**ROADSTER
WARRANTY
Bulletin**

Subject: **Spyder™ RT – Rear Top Storage
Compartment Cover Adjustment**

No. **2011-8**

1. Retaining screws

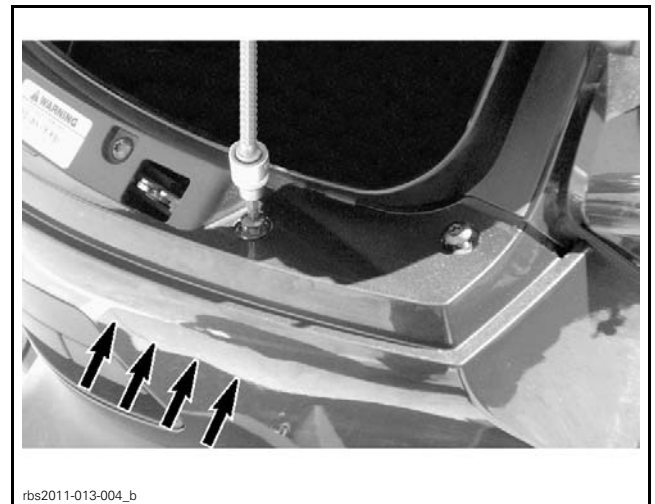
1. Open cover.
2. Loosen the four screws retaining the rear panel.

3. Have an assistant to push the rear panel forward while you torque the four previously loosened screws to specification.

APPLY PRESSURE ON REAR PANEL WHILE TIGHTENING SCREW

TIGHTENING TORQUE	
Rear panel retaining screw	3.5 N•m (31 lbf•in)

rbs2011-013-005_a

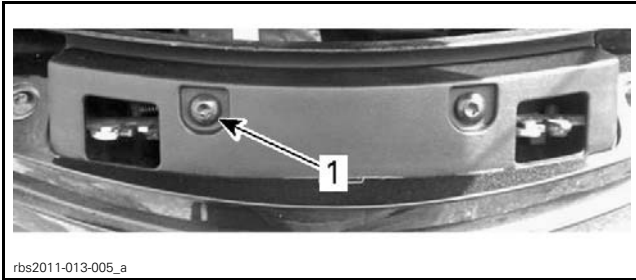
1. Remove the first retaining screw securing the latch mechanism.

NOTICE To avoid latch falling away from its mounting area, remove one screw at a time. Loosen the second screw slightly to allow the latch to move away from its mounting area so it will not be damaged when enlarging the first hole in the panel.

1. Remove this screw ONLY

rbs2011-013-003

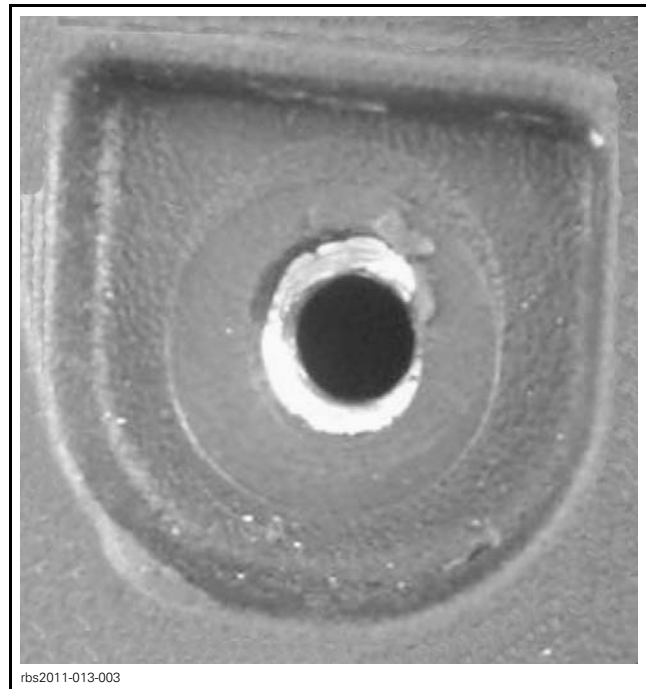
2. Using a small rotary tool, enlarge the empty panel screw hole upward to make it oblong for more adjustment.

SPECIFICATION	
Maximum enlargement size	2 mm (5/64 in)

NOTICE Do not enlarge more than 2 mm (5/64 in) otherwise the head of the screw will come in contact with the side of mechanism.

NOTICE Be careful not to grind the metallic section as this will damage the threads.

TYPICAL - AFTER MODIFICATION

rbs2011-013-006_a

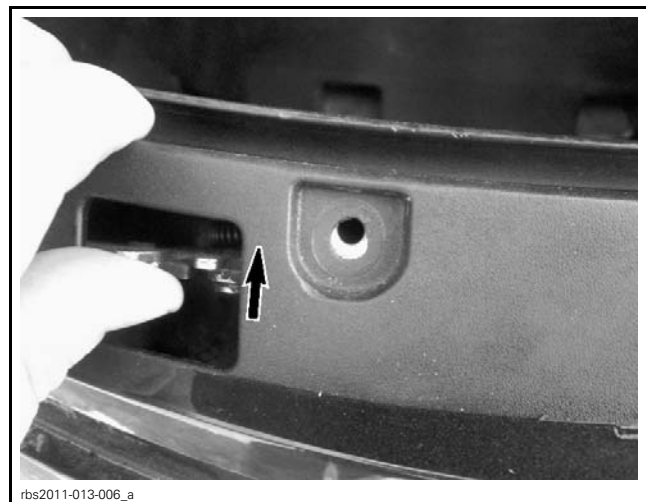
- Loosely install first latch screw.
- NOTE: Do not tighten screw at this time.
- Repeat procedure for the other side.
 - While holding the latch mechanism up lightly tighten both retaining screws.
 - Verify that the cover closes properly and is contacting the seal all the way around. If necessary move latch up or down in slotted holes to achieve proper fit.

SCREW NOT SHOWN FOR CLARITY - PUSH ON LATCH MECHANISM UP

rbs2011-013-005_b

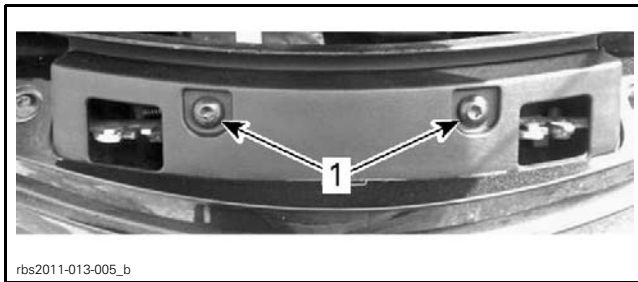
- When proper fit is achieved, tighten both latch mechanism retaining screws to specification.

1. Latch mechanism retaining screws

TIGHTENING TORQUE	
Latch mechanism retaining screw	2.5 N•m (22 lbf•in)
